VALUE ENGINEERING REPORT

East Hiram Parkway
Project No.: MSL-0004-00(688) Paulding County
PI No.: 0004688

December 12, 2007

C-1
Pg 2 of 9

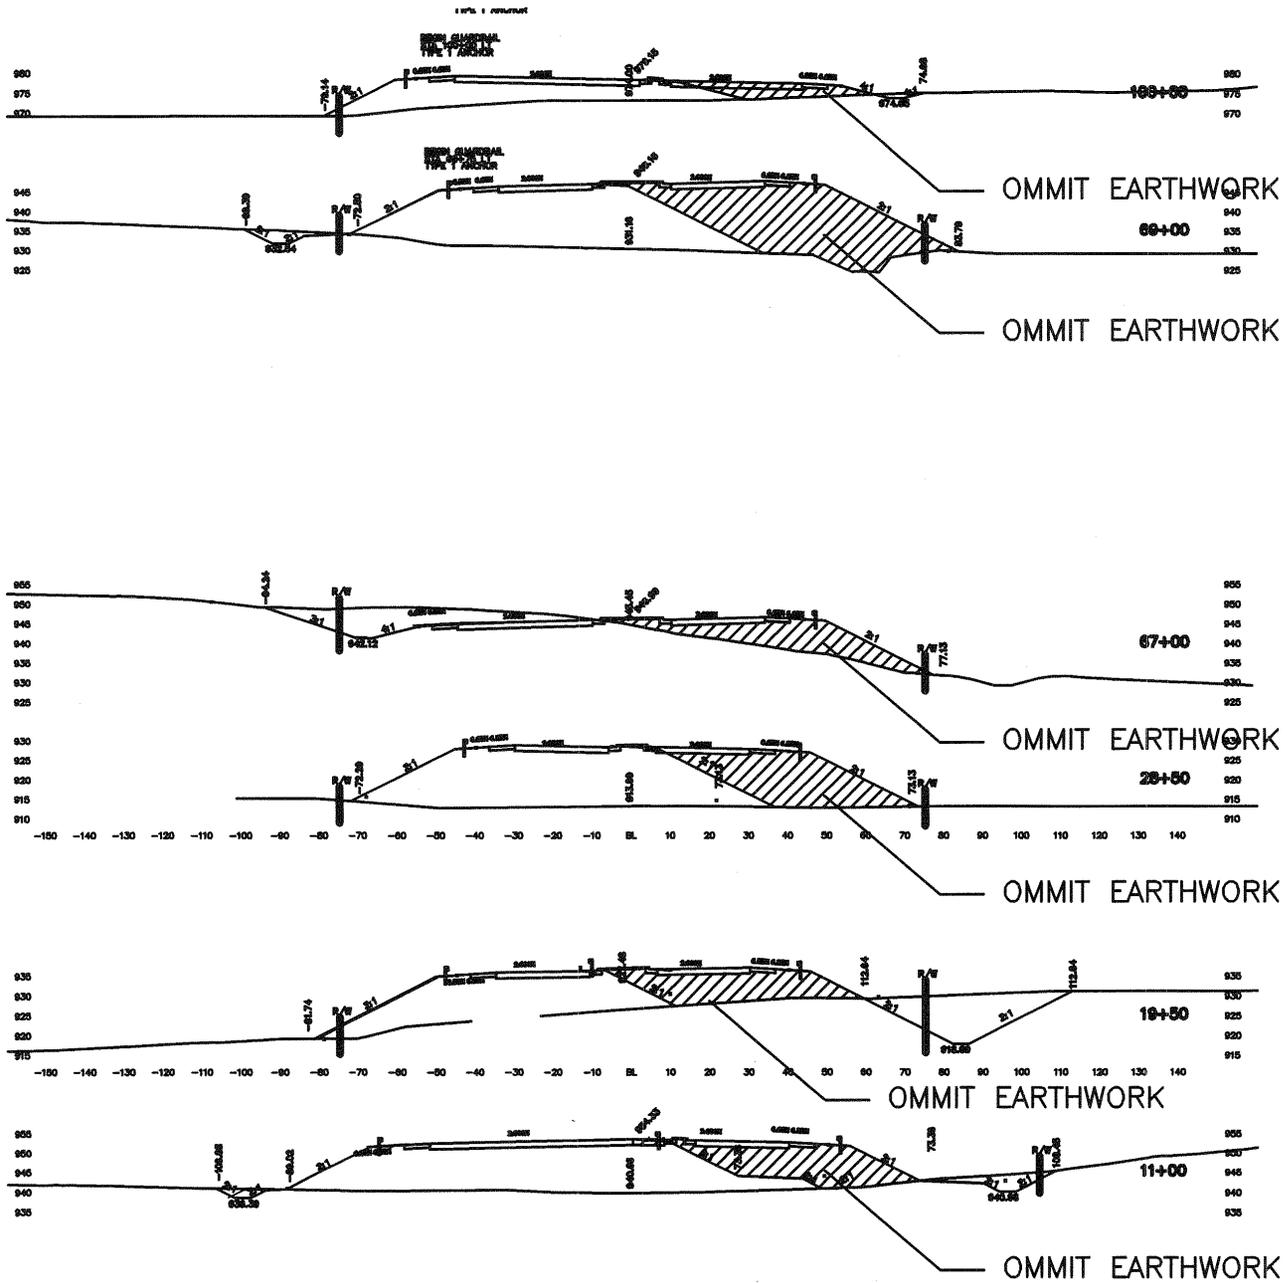
Build 2-lane rural section without median along original westbound alignment. 2-lane rural section will tie into original concept 4-lane urban section. Right of way will be purchased as required for original 4-lane with median concept.

Reduce grading, pavement, drainage, bridge, and curb & gutter costs, and wetlands mitigation. Future widening to be reserved as funds are available and as traffic demands or development warrant additional lanes.

ITEM N^o: C-3
CLIENT: GDOT
Sheet 2 of 5

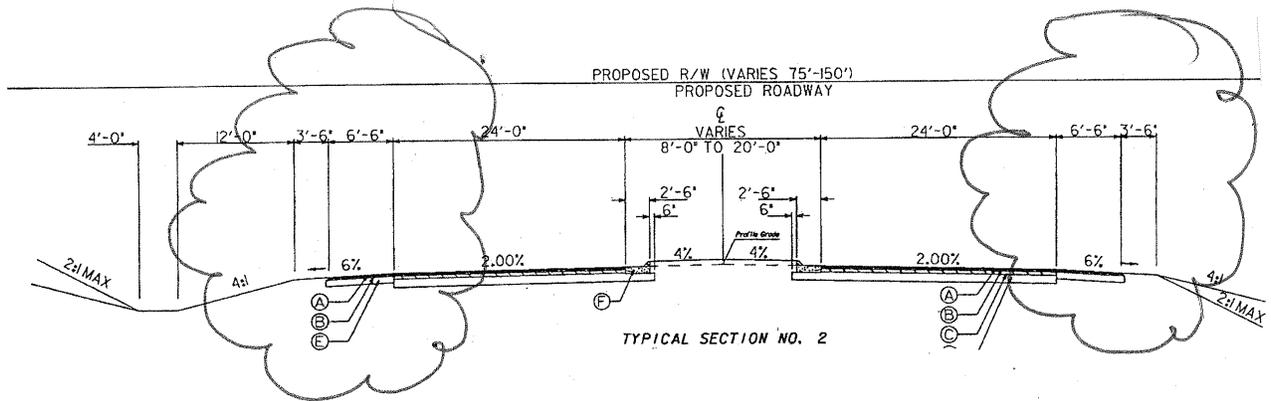
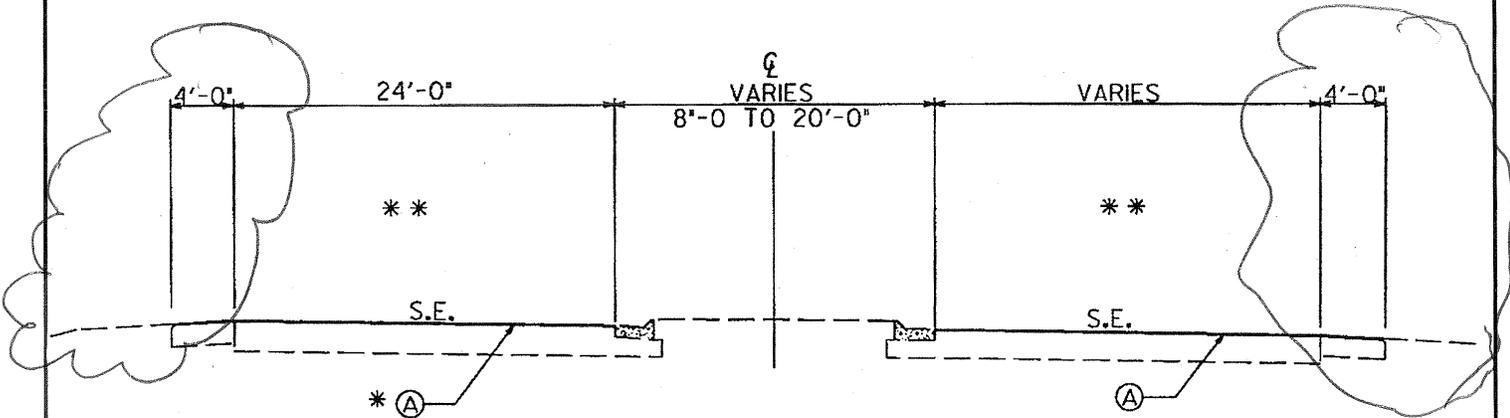
The typical section shows an outside shoulder consisting of a paved 6.5 foot shoulder followed by a 3.5 foot section to the grade break. The proposed change shows a 4.0 foot paved length with a 6.0 foot graded aggregate base section to the break. This shoulder section matches the existing section at Bill Carruth Parkway and provides adequate room for vehicles to access the shoulder in case of an emergency as well as a paved surface for bicycles to ride on.

ITEM N^o: E-1
 CLIENT: GDOT
 Sheet 2 of 5

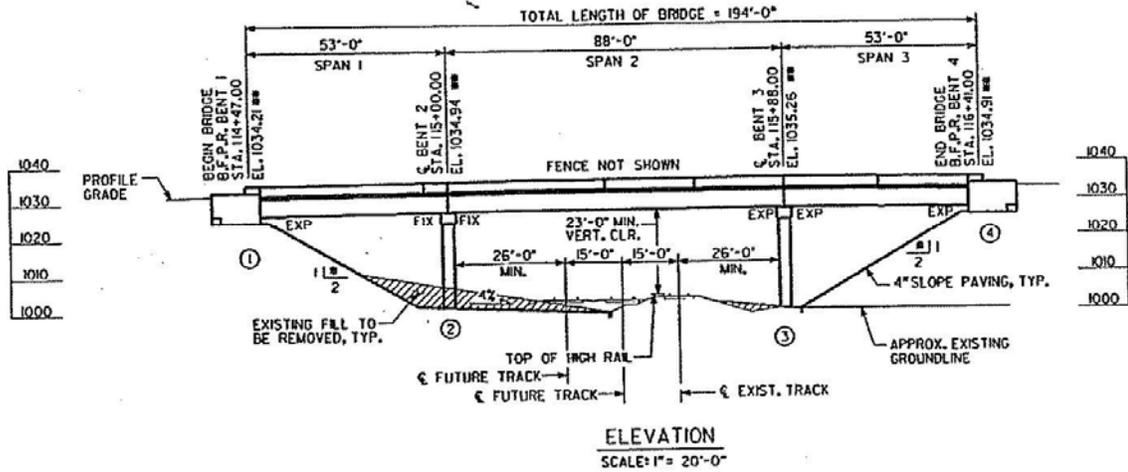
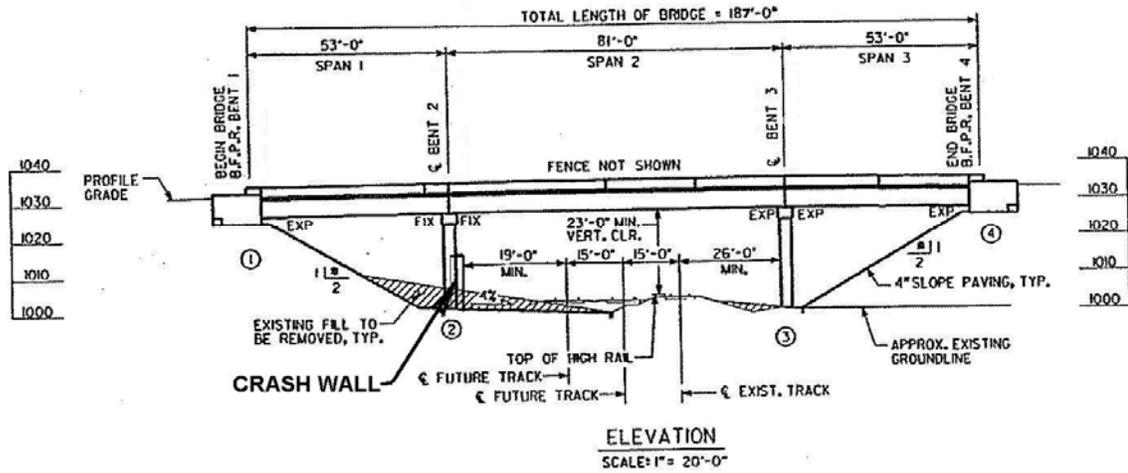
The addition of the 2nd track is highly likely, however adding a 3rd track is less likely. The recommended design allows for the 3rd track, but requires a crash wall be added.

ITEM N^o: E-2
 CLIENT: GDOT
 Sheet 2 of 5

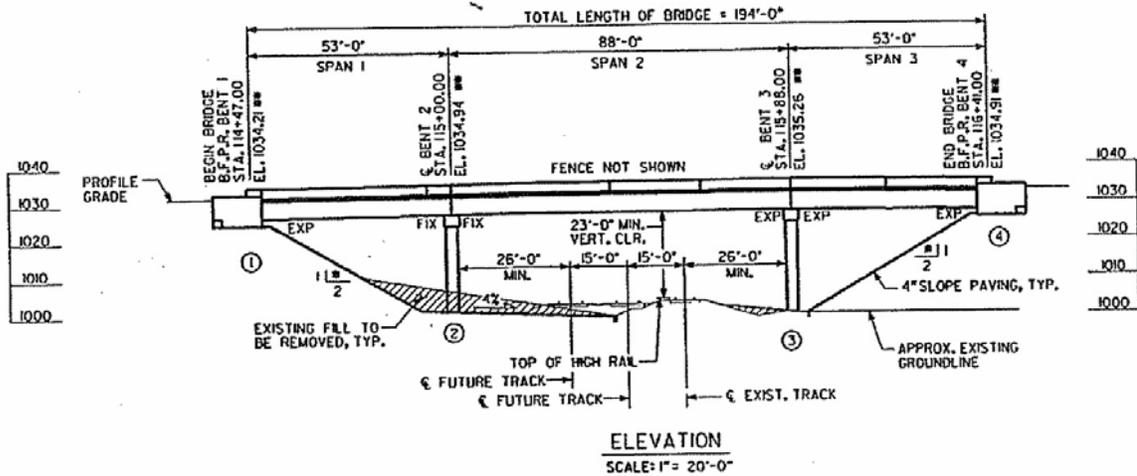
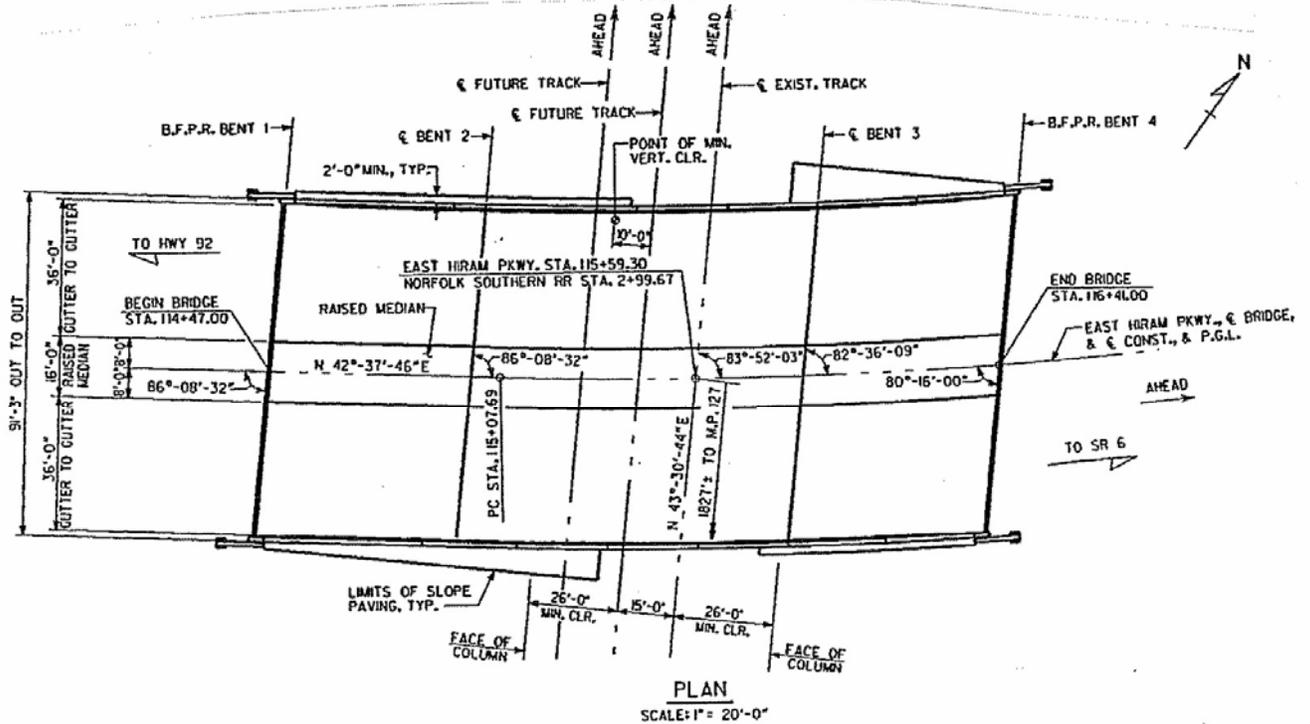
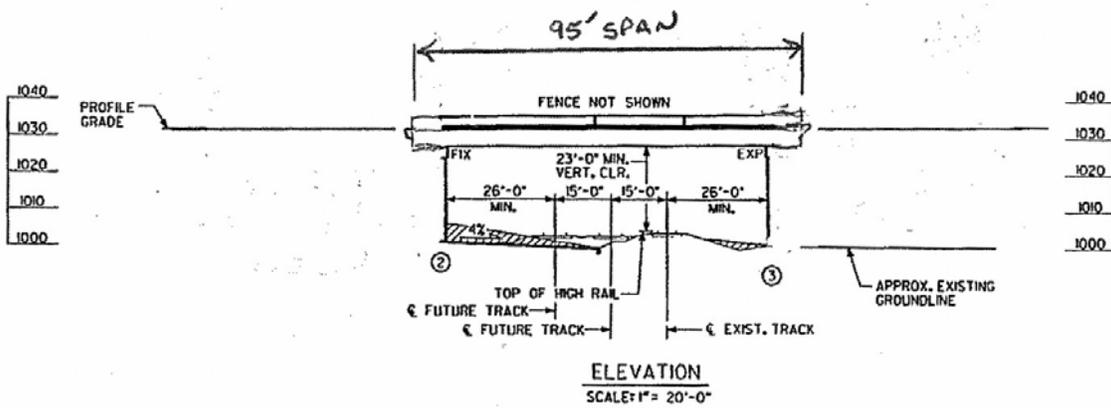
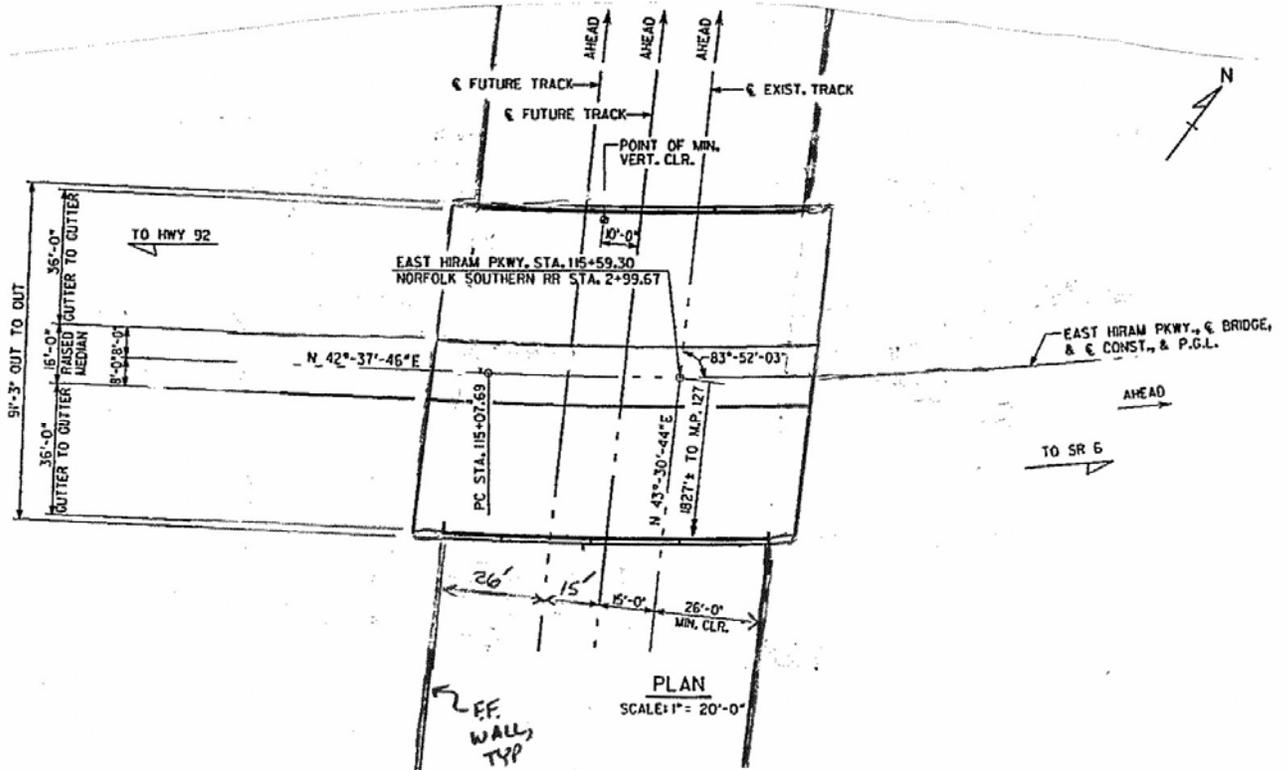
This concept is to use MSE walls and eliminate the end spans thus shortening the bridge length substantially. The pavement section and MSE walls are less costly than the bridge unit costs.

ITEM N^o: E-3
CLIENT: GDOT
Sheet 2 of 4

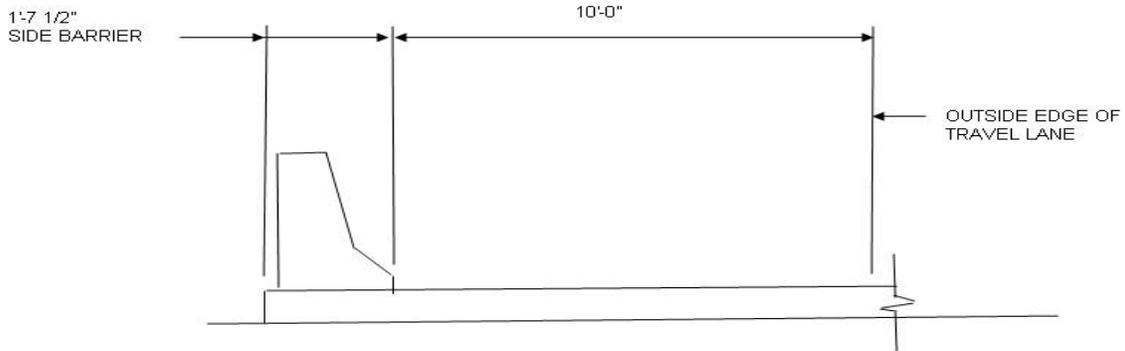
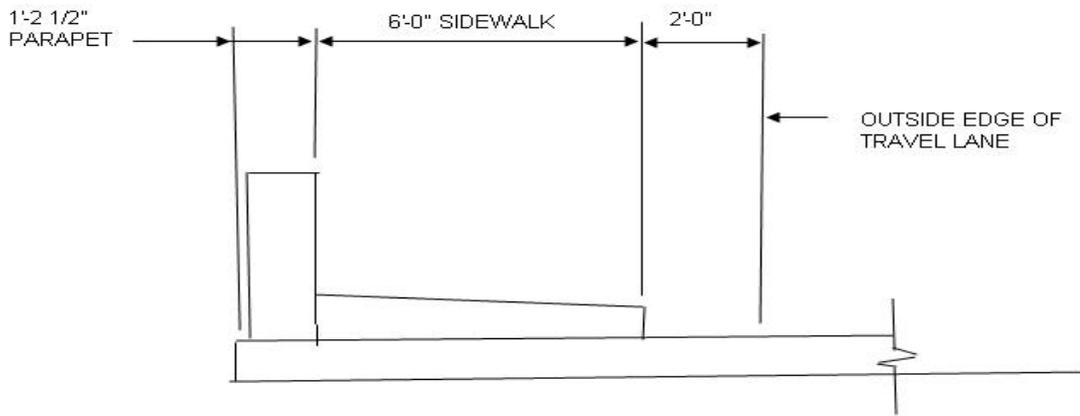
The urban section includes a sidewalk on the bridge and appears to be reasonable for the Angham Road area. This results in a narrower bridge and thus savings in construction costs.

ITEM N^o: E-4
CLIENT: GDOT
Sheet 2 of 4

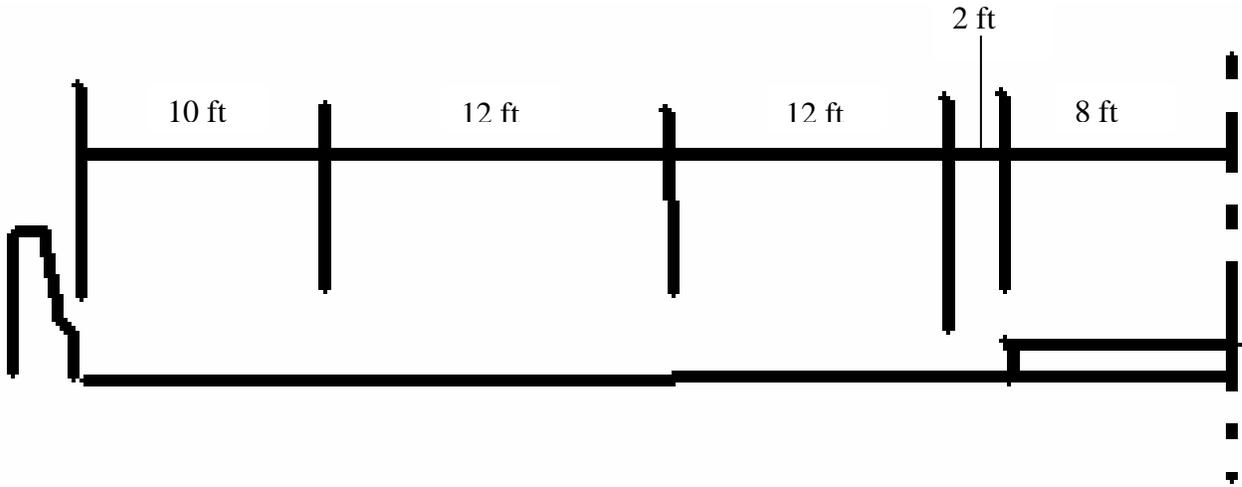
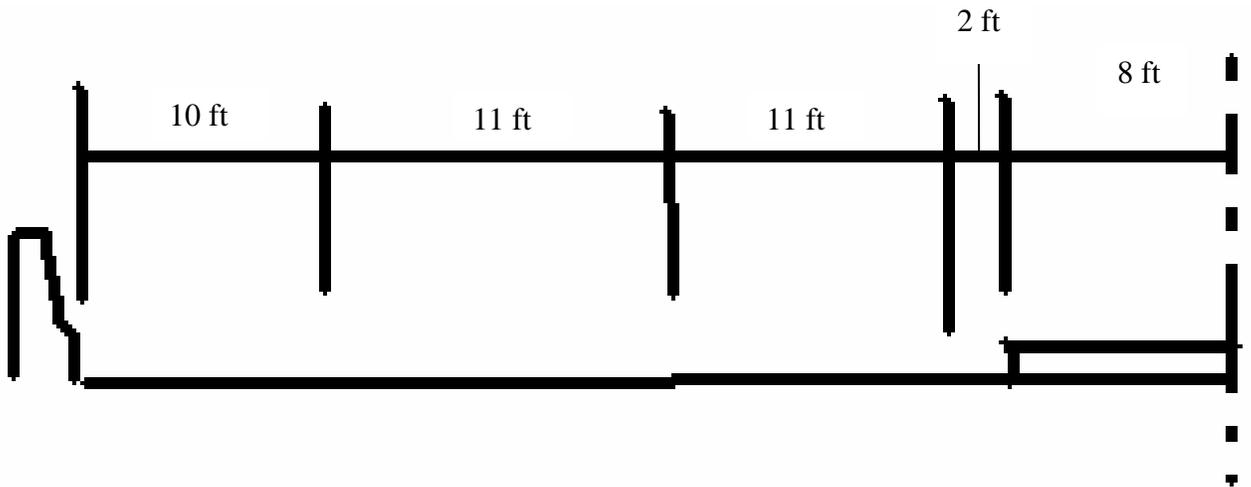
E-4 Reduce lane width on Bridge #3 to 11 feet

ITEM N^o: G-1
CLIENT: GDOT
Sheet 2 of 4

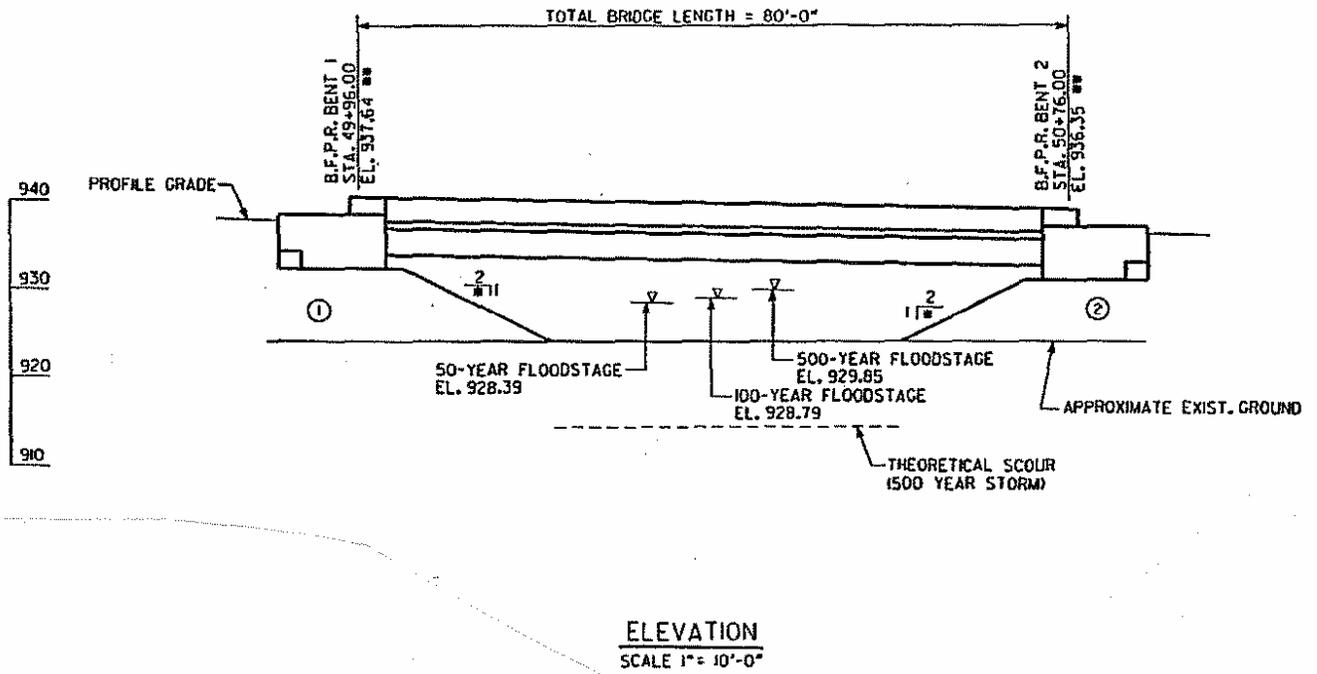
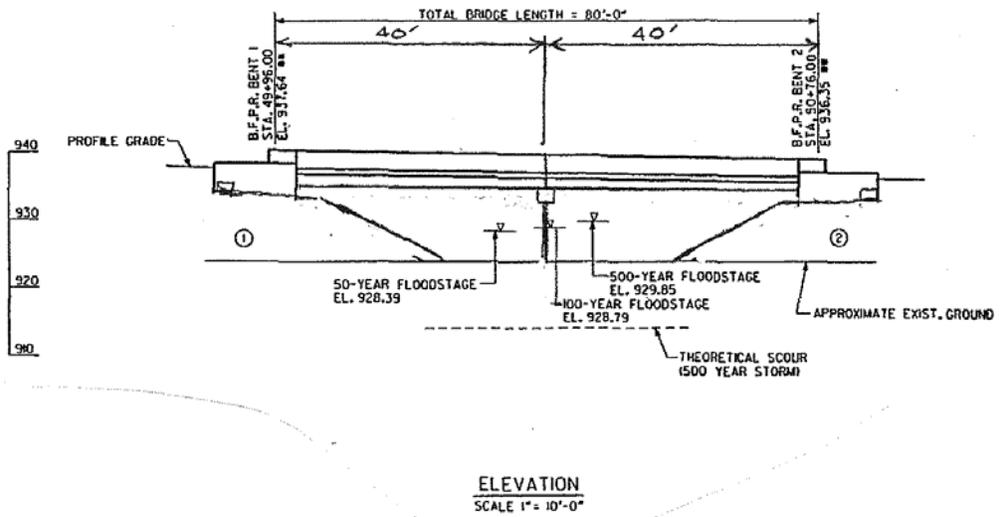
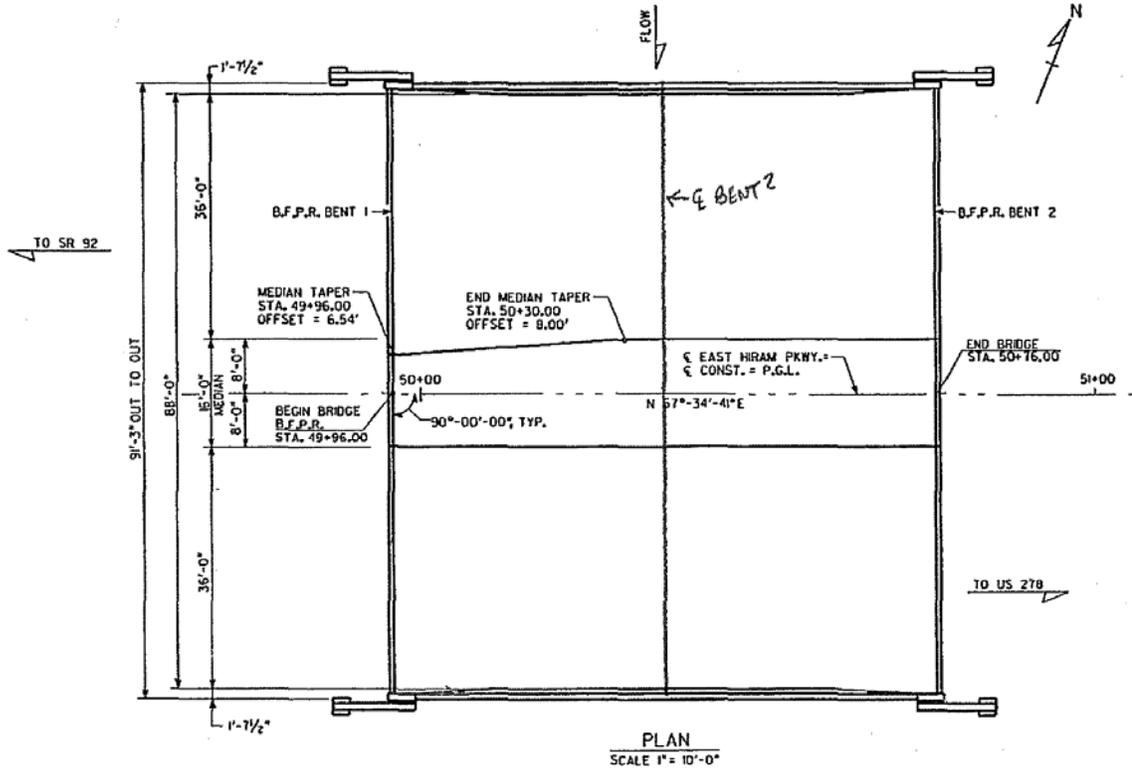
Two 40 foot spans allow for the use of T beams that are more economical and much shallower allowing for a lower profile.
